FIELD ORDER SUMMARY

Project: Saranac Lake Gas Co. Remedial Action	Project Location: Village of Saranac Lake, Essex County, New York
Client: NYSDEC	NYSDEC Site No.: 516008
Contractor: LAND Remediation, Inc.	MACTEC Project No.: 3611181219

FIELD ORDER

Project Name:	Saranac Lake Gas Company, Remedial Action	FO No.: 1
Project Location:	Village of Saranac Lake, Essex County, New York	Date Issued: 7/17/2018
		Site No.: 516008
Client:	New York State Department of Environmental Conservation (Department)	Contract No.: D010663
Contractor:	LAND Remediation, Inc.	Associated RFI or PCO: <input type="checkbox"/> RFI No. ___ <input checked="" type="checkbox"/> PCO No. 4 <input type="checkbox"/> None
MACTEC Project No.:	3611181219

FO6-1

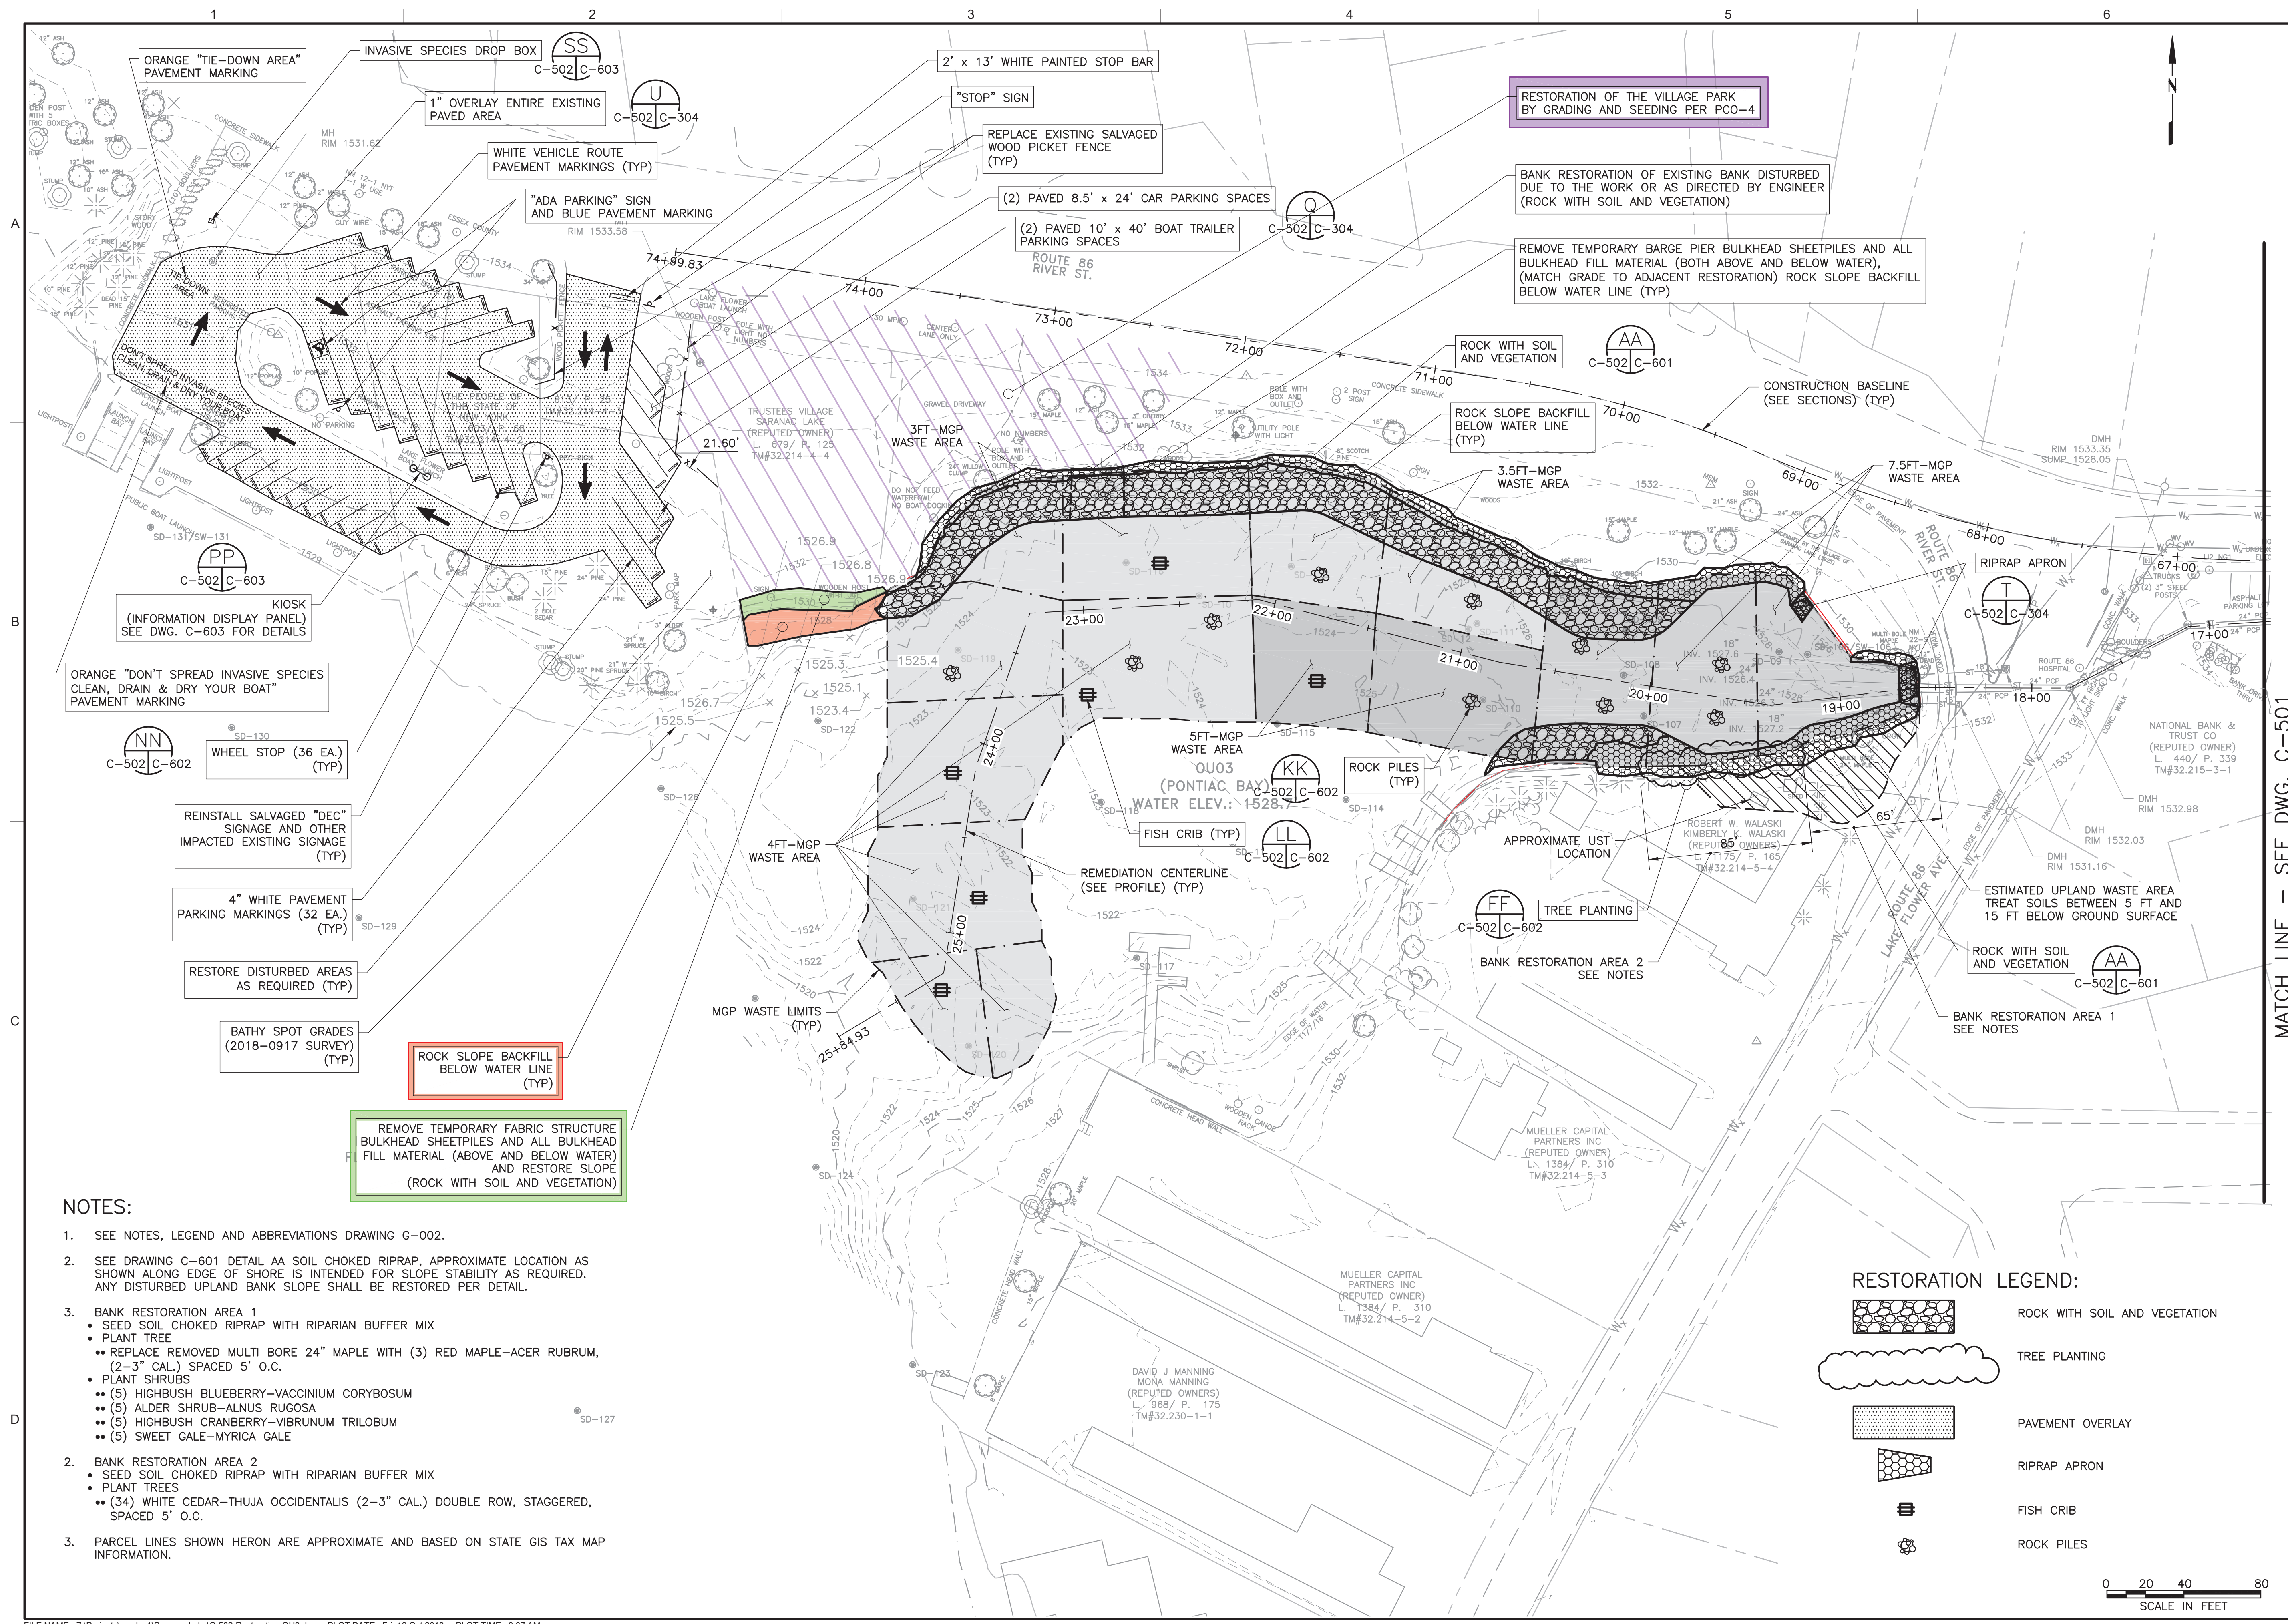
- NOTES:**
- SEE NOTES, LEGEND AND ABBREVIATIONS DRAWING G-002.
 - SEE DRAWING C-601 DETAIL AA SOIL CHOKED RIPRAP, APPROXIMATE LOCATION AS SHOWN ALONG EDGE OF SHORE IS INTENDED FOR SLOPE STABILITY AS REQUIRED. ANY DISTURBED UPLAND BANK SLOPE SHALL BE RESTORED PER DETAIL.

- BANK RESTORATION AREA 1
 - SEED SOIL CHOKED RIPRAP WITH RIPARIAN BUFFER MIX
 - PLANT TREE
 - REPLACE REMOVED MULTI BORE 24" MAPLE WITH (3) RED MAPLE-ACER RUBRUM, (2-3" CAL.) SPACED 5' O.C.

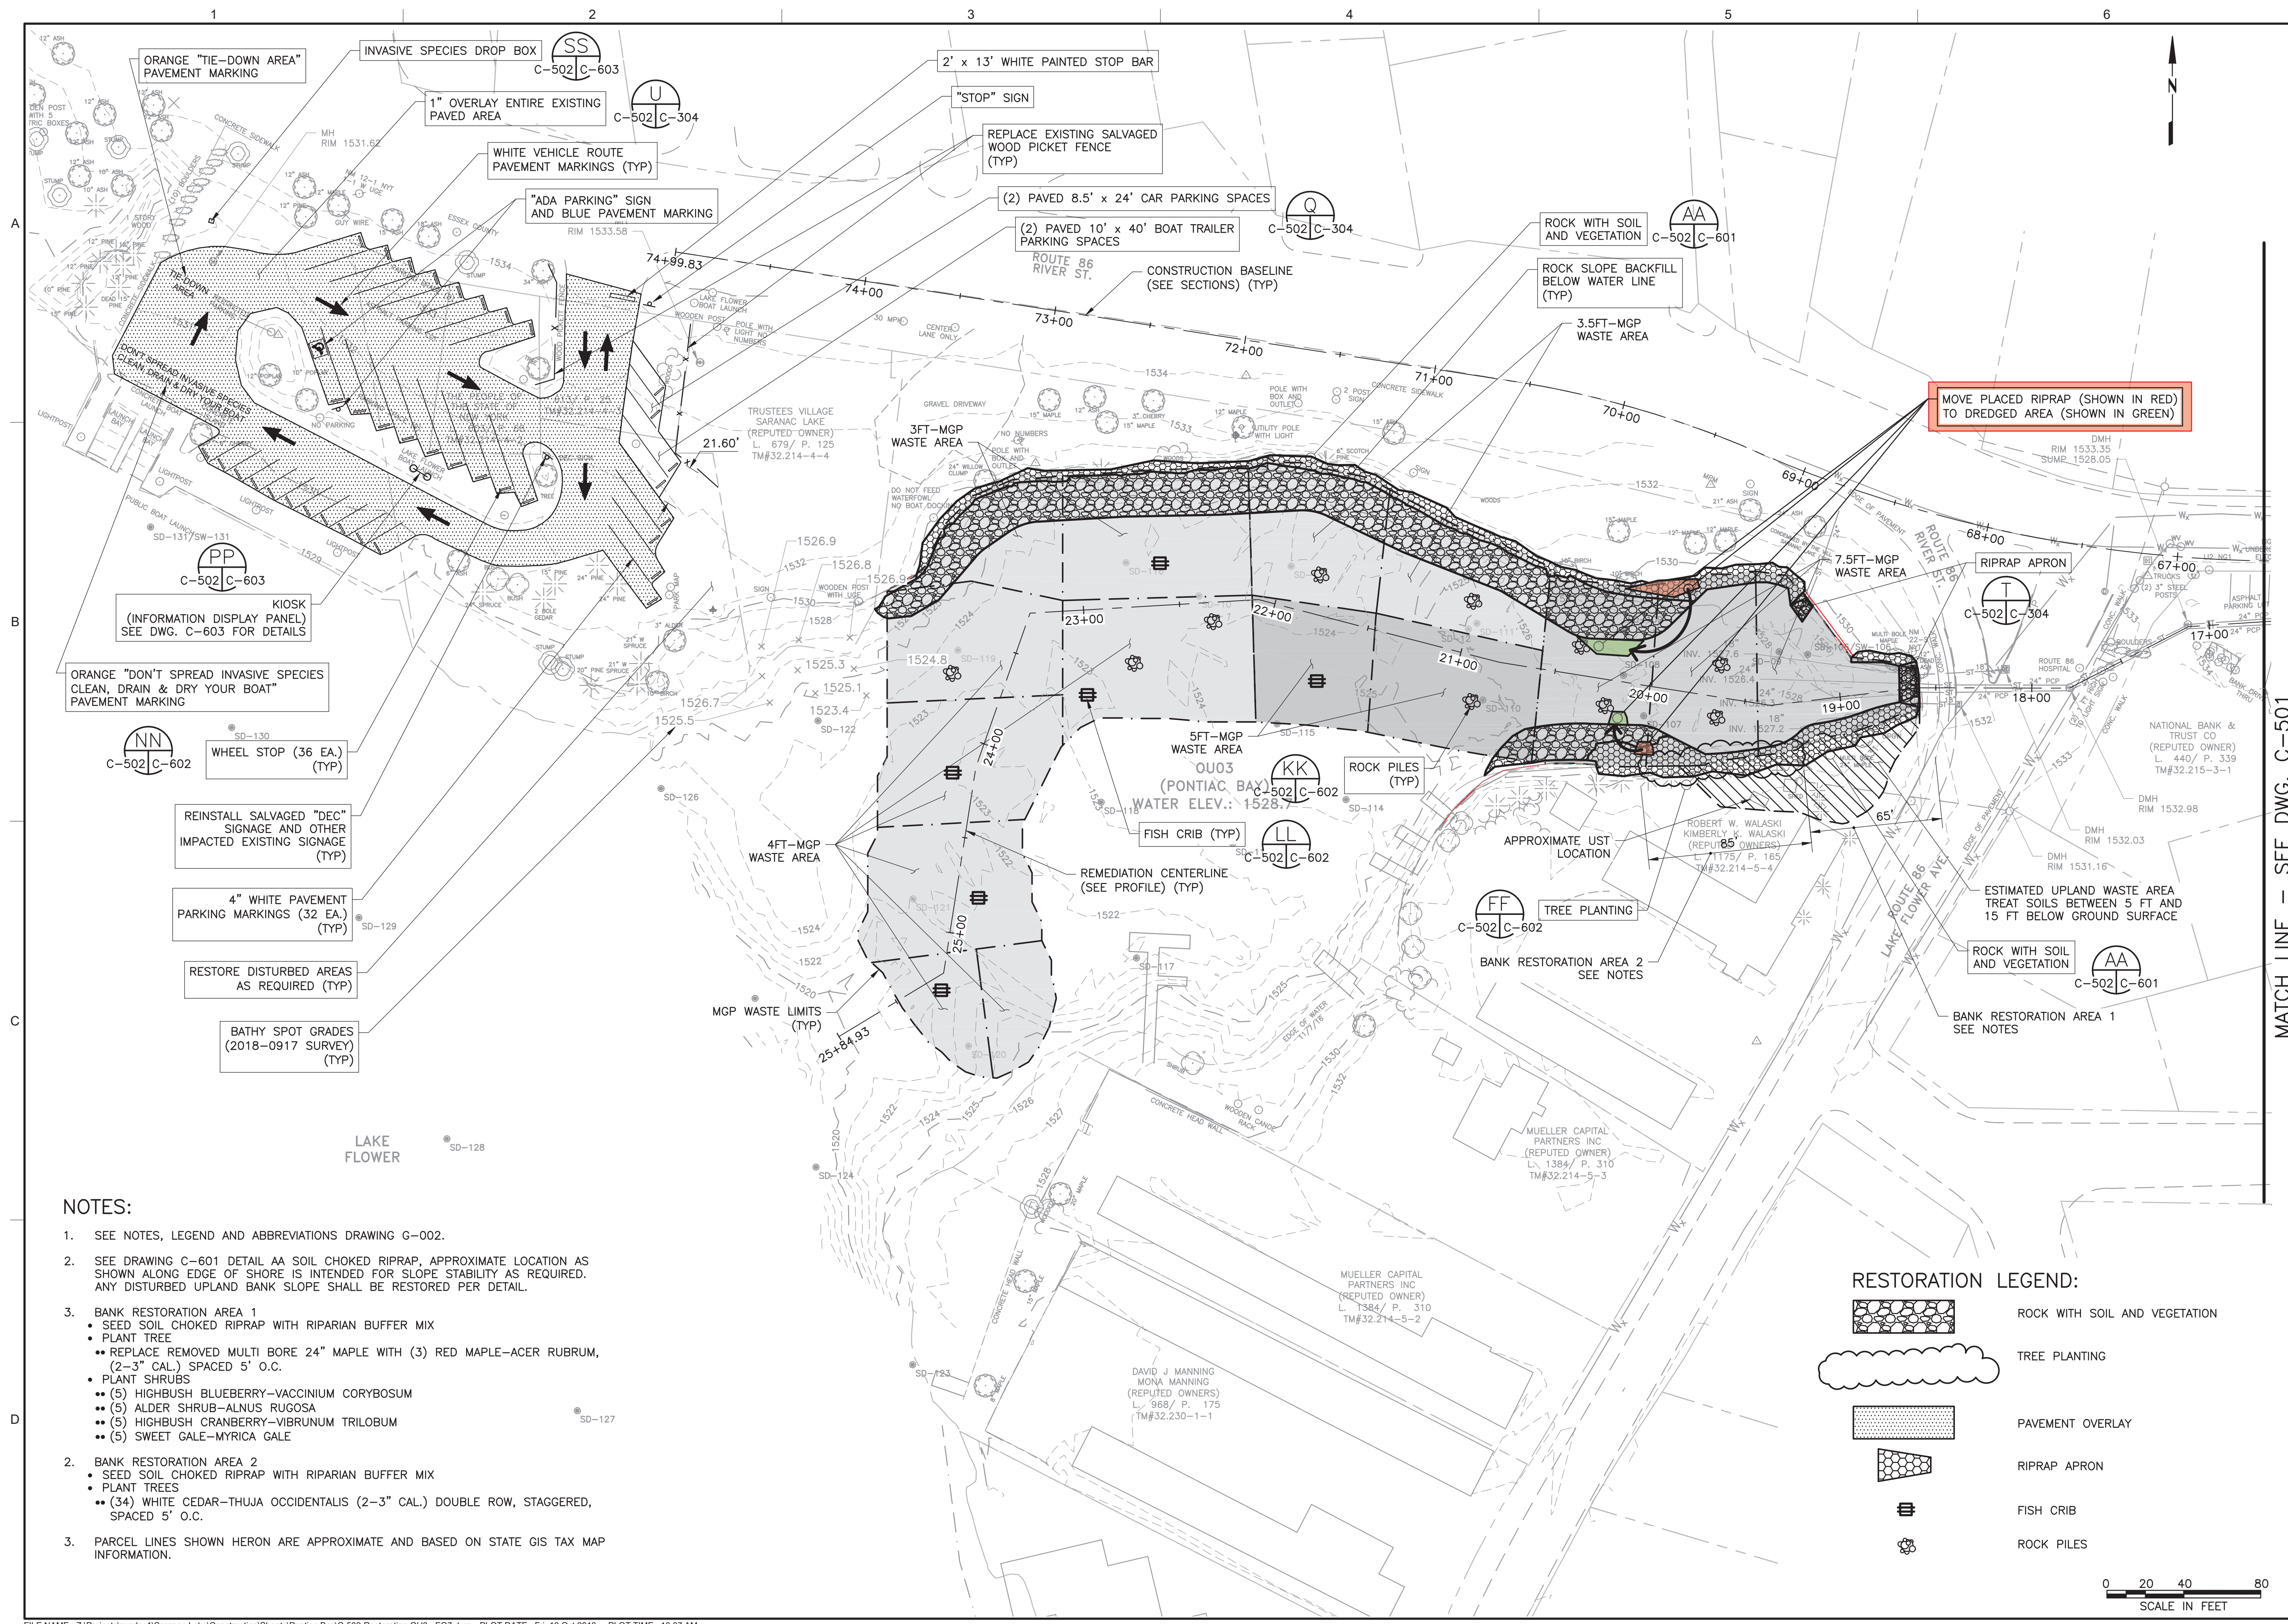
PCO 6 – Revision 1 revised the approach for backfilling the bay to use riprap in the bay on the dredged shoreline slopes.

MOVE PLACED RIPRAP (SHOWN IN RED) TO DREDGED AREA (SHOWN IN GREEN)
